LEARMONT ADDITION TO SEDGWICK COUNTY, KANSAS

RE: S/D 99-9 -- One-Step Final Plat of LEARMONT ADDITION

RE: S/D 99-9 -- One-Step Final Plat of LEARMONT ADDITION

CASE NUMBER: S/D 99-9 - LEARMONT ADDITION

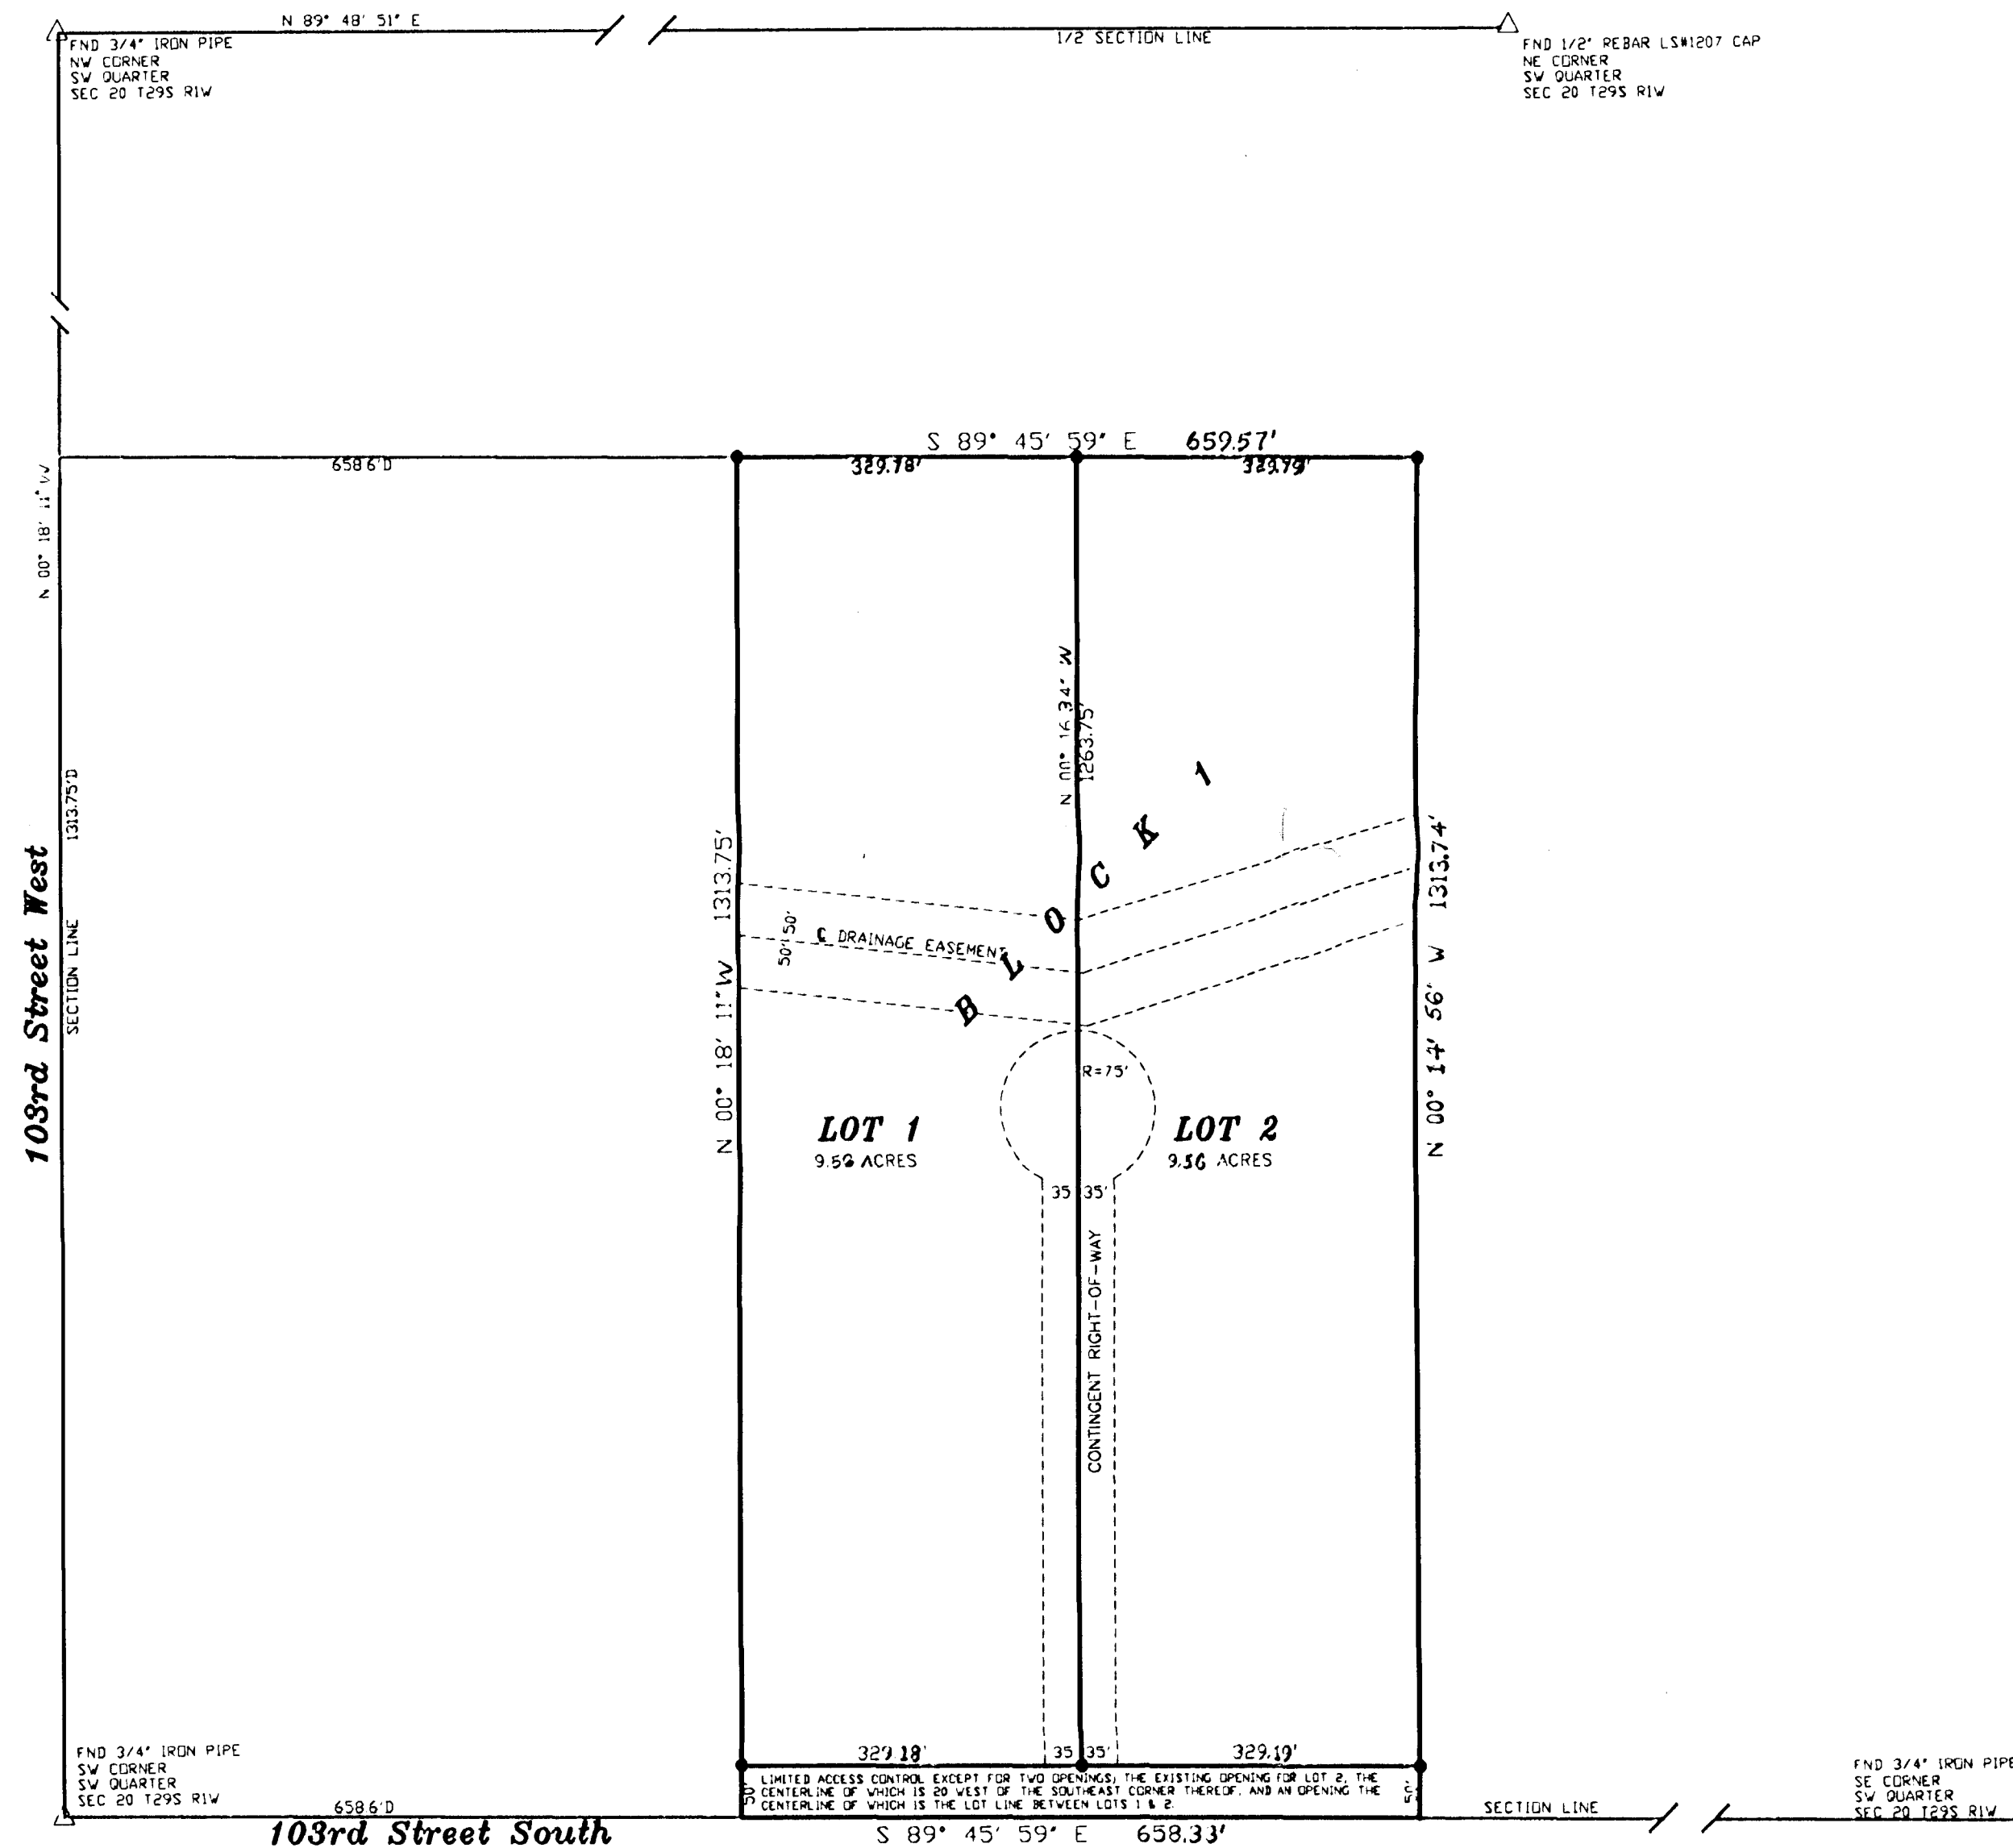
- C. County Engineering needs to comment on the status of the applicant's drainage plan. The drainage plan is approved.
- D. A 70-ft contingent dedication of right-of-way may be platted on the common line between Lots 1 and 2, to allow for future division of the northern portion of the site. A turnaround would also be recommended.

- E. Access controls need to be dedicated on the face of the plat and referenced in the plat's text. The access to Lot 2 shall be limited to an opening within the contingent right-of-way.

- ✓ F. The Planning Commission signature block needs to include a date of approval.
- ✓ G. The owner's signature block needs to be revised to indicate that the site is in the ownership of the party denoted in the platting binder.

- C. County Engineering needs to comment on the status of the applicant's drainage plan. The drainage plan is approved.
- D. A 70-ft contingent dedication of right-of-way may be platted on the common line between Lots 1 and 2, to allow for future division of the northern portion of the site. A turnaround would also be recommended.

- E. Access controls need to be dedicated on the face of the plat and referenced in the plat's text. The access to Lot 2 shall be limited to an opening within the contingent right-of-way.

- F. The Planning Commission signature block needs to include a date of approval.
- G. The owner's signature block needs to be revised to indicate that the site is in the ownership of the party denoted in the platting binder.
